**Subject: Agostini Minor Subdivision – 68 Magnolia St Bristol, RI [Plat: 23, Lot: 185, 189, 192]  
(NEI job 23.0144) REV.1**

### Response to Preliminary Application Comments

RE: Agostini Minor Subdivision  
68 Magnolia St Bristol RI  
Tax Assessor's Plat: 23  
Tax Assessor's Lot: 185,189,192

**SV-100**

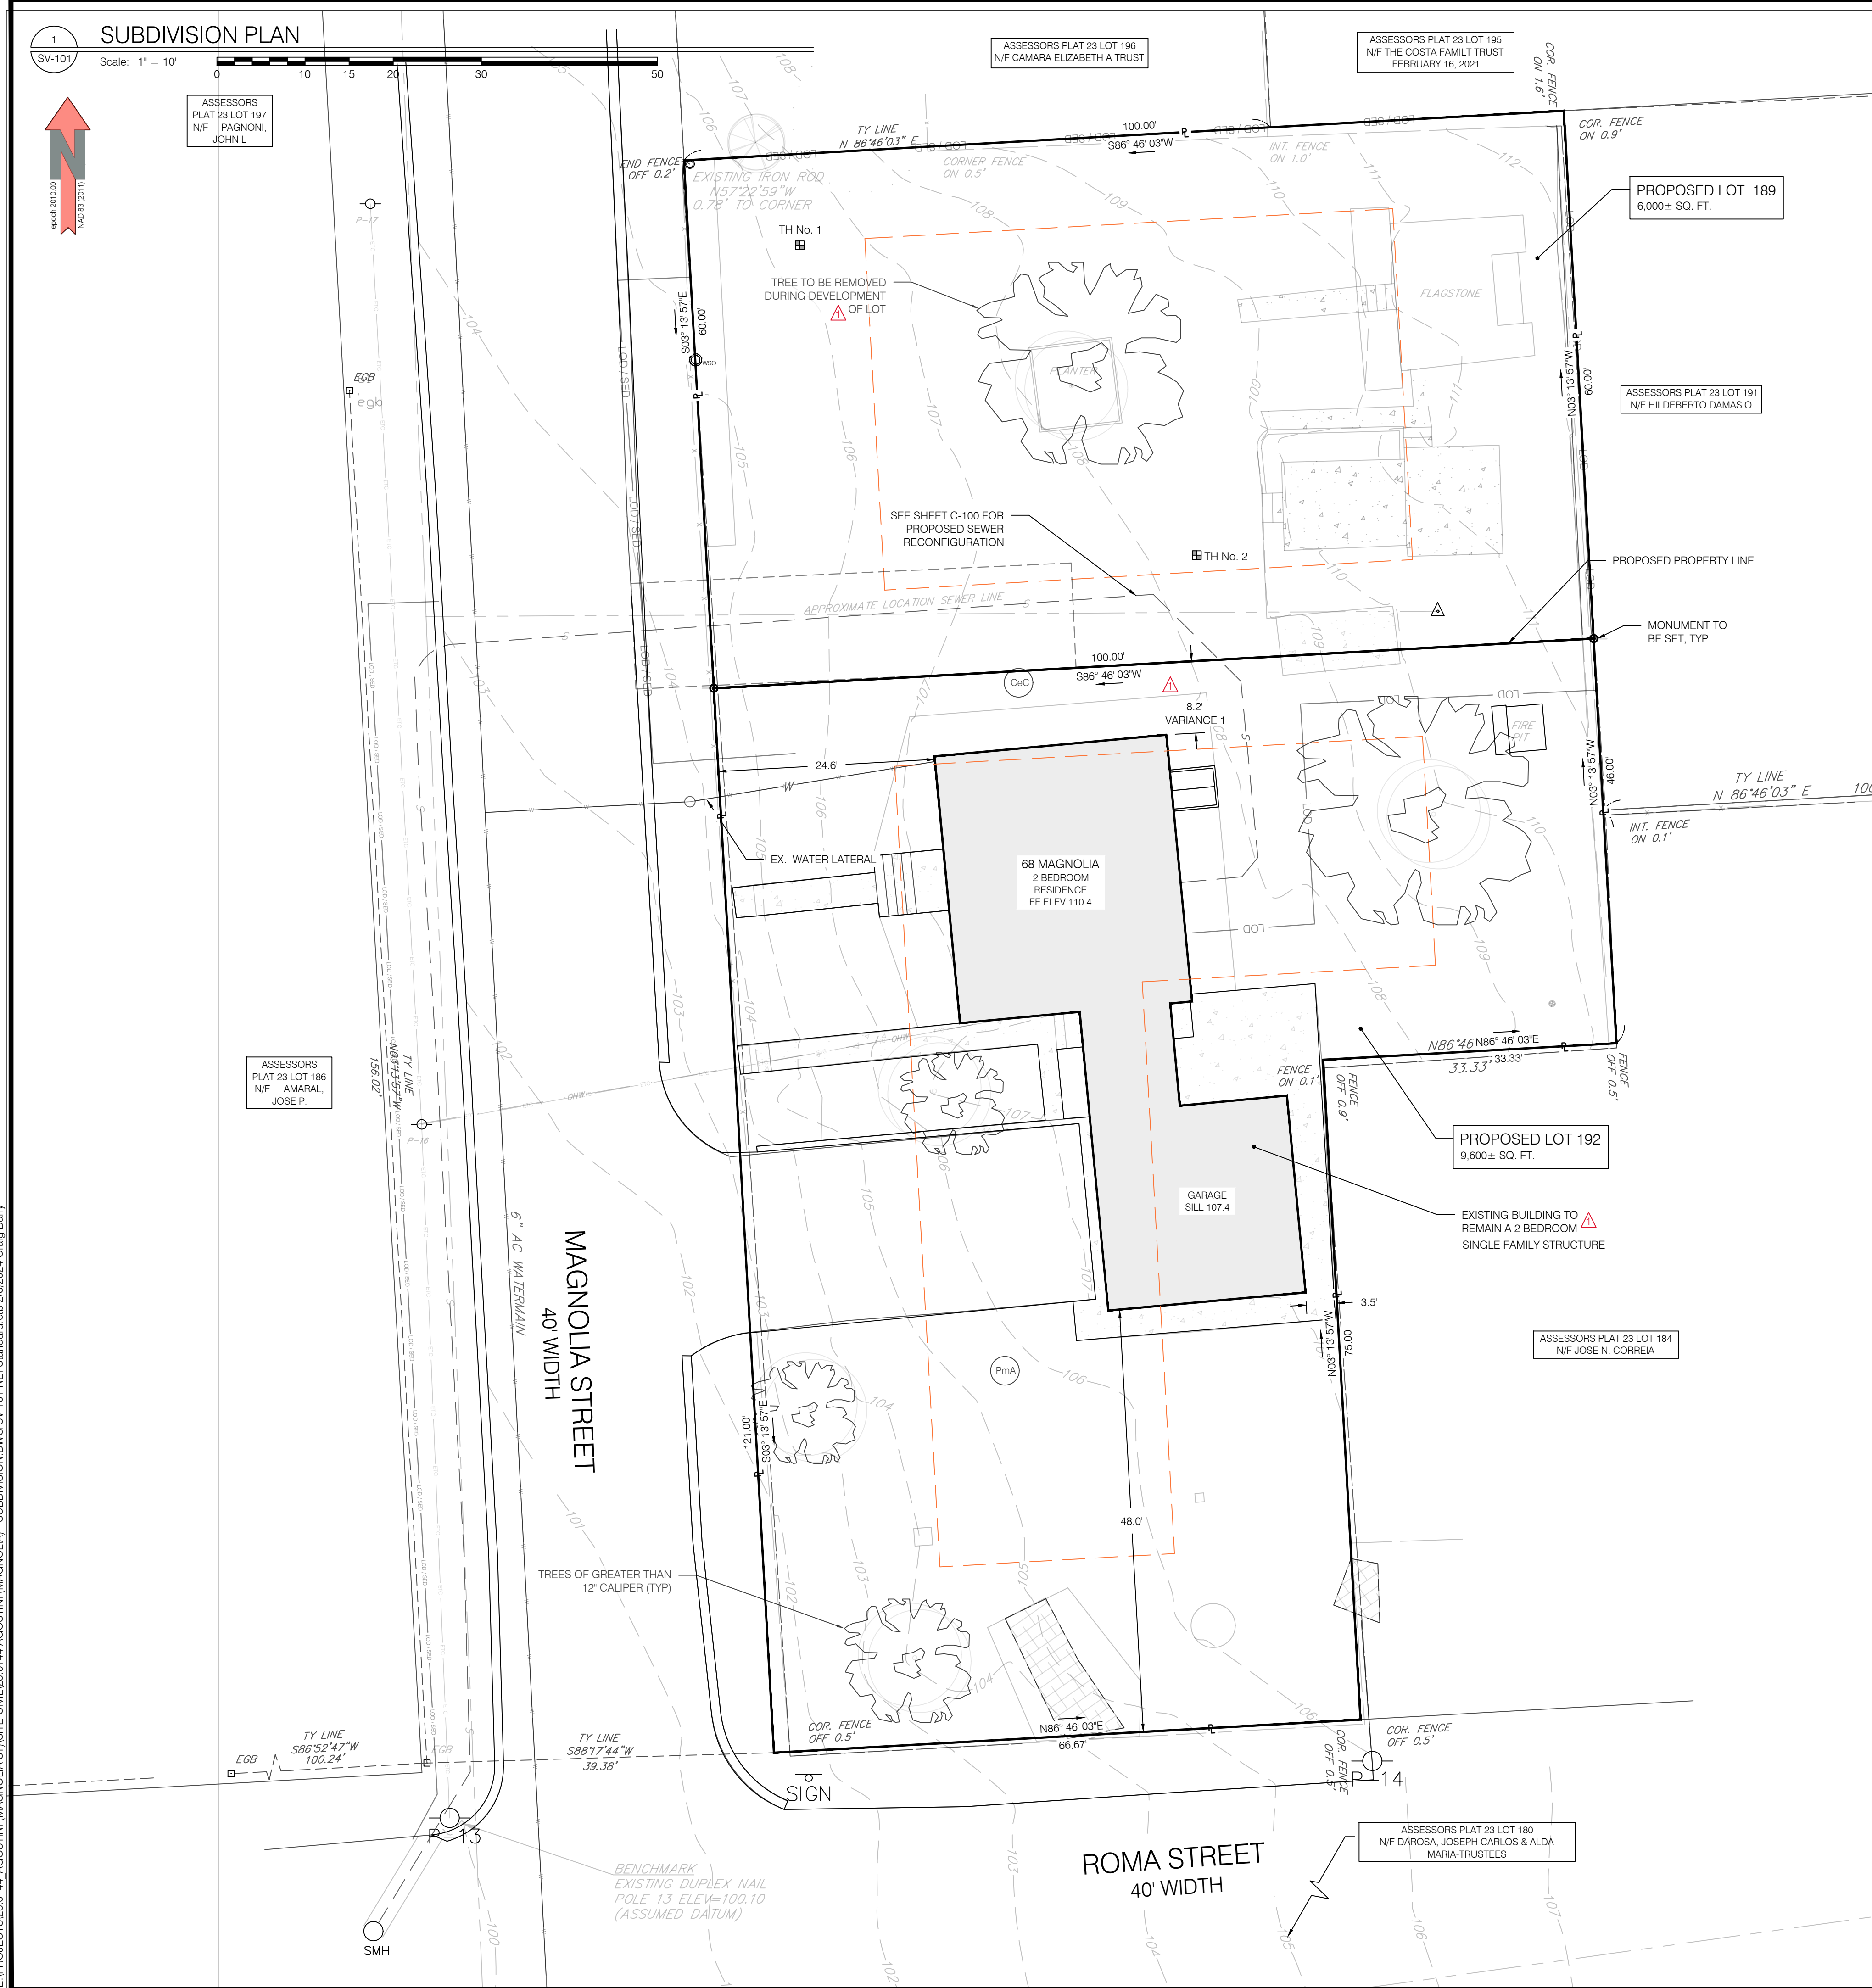
1. Plans must include a notation with the Flood Zone Designation (B19)

[A FEMA Flood map has been added to sheet SV-100 and note 11 in survey notes has been updated to designate the flood zone. This site is not in a flood zone.](#)
